Office Action Summary

09/913,635

RUCKERT ET AL.

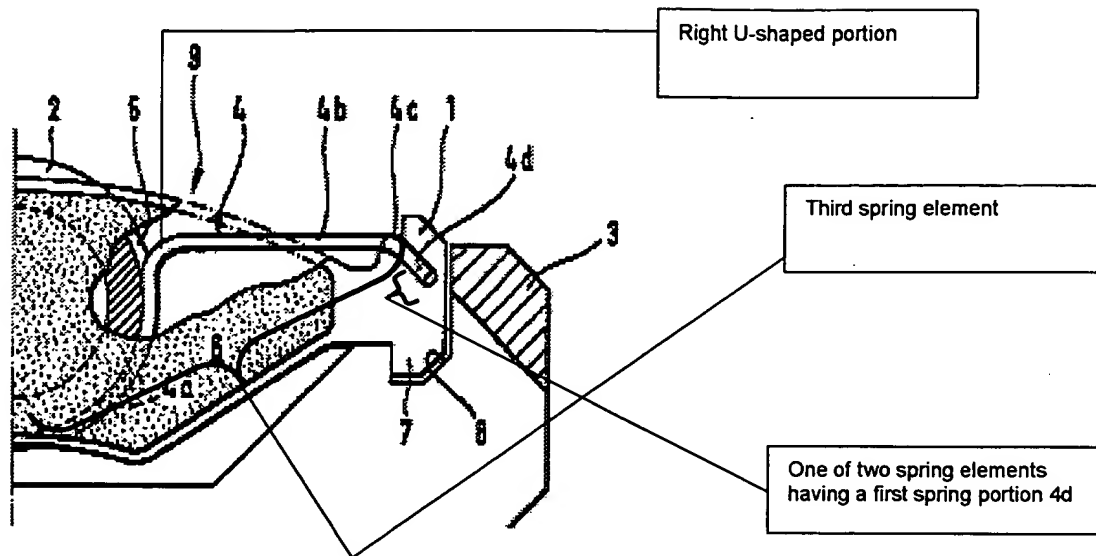
4. Claims 19, 28, 29, and 31-35 are rejected under 35 U.S.C. 102(b) as being anticipated by DE-19705803 to Winter.

Re: claims 28, 31, 32 and 34. Winter shows in figure 1 a brake pad 9 and brake piston assembly, comprising: a brake piston 2 having an axis and an outer surface encircled by a circumferential groove 5, a retaining spring 4 coupled to a brake pad 1,6, wherein the retaining spring engages the circumferential piston groove as shown in figure 2, thereby detachably coupling the brake pad to the piston, wherein the retaining spring includes two spring elements as labeled in the modified version of figure 1 on pg. 4 of the Office Action arranged opposite each other with respect to the piston axis, each spring element having a first spring portion left and right side elements 4d which applies an axial spring force as discussed in the second paragraph on pg. 4 of the translation of Winter at a contact point location on opposite sides of the piston to urge the brake pad against the piston, and a third spring element as labeled on pg. 4 arranged between the two spring elements (left and right spring elements) having a second spring portion 4c which applies a radial spring force as discussed in the second paragraph on pg. 4 of the translation of Winter to the brake pad at one contact point location in a vertical direction which is generally perpendicular to the piston axis.

Re: claims 19 and 33. Winter shows in figure 1 the brake pad including a carrier plate 1 and a friction lining 6.

8. Applicant's arguments with respect to claims have been considered but are moot in view of the new ground(s) of rejection. Examiner has considered an alternate perspective of Winter. With regards to claim 31, it is noted that the claim language does not preclude the use of spring sections as spring elements. Examiner notes that the first definition in section 2 of the definition of the word "element" provided by Applicant is "a constituent part". Examiner notes that the spring elements shown in the modified version of figure 1 on pg. 4 of the Office Action are constituent parts.
